Access Compliance Report

Public Rights-of-Way

(Curb Ramps)

| Intersection ID: 14393 | Main Street: BERKELEY_AV | Cross Street: LEXINGTON_AV | Location: SW |

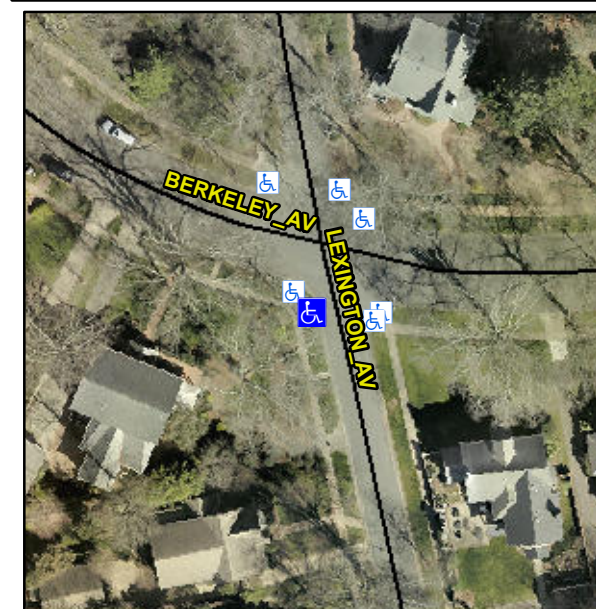
| ADA ID: F6C4D1C85D6A | Ramp Type: Perp | Initial Pass/Fail: Fail | Overall Compliance: No |

Not Found, R304.5.3

| Compliance | Description | Data | Compliance | Description | Data |
|------------|-----------------------|------|------------|-----------------------------|------|
| Yes | Ramp Width (in) | 60.0 | No | Ramp XSlope (%) | 2.2 |

Remove & Replace Entire Ramp.
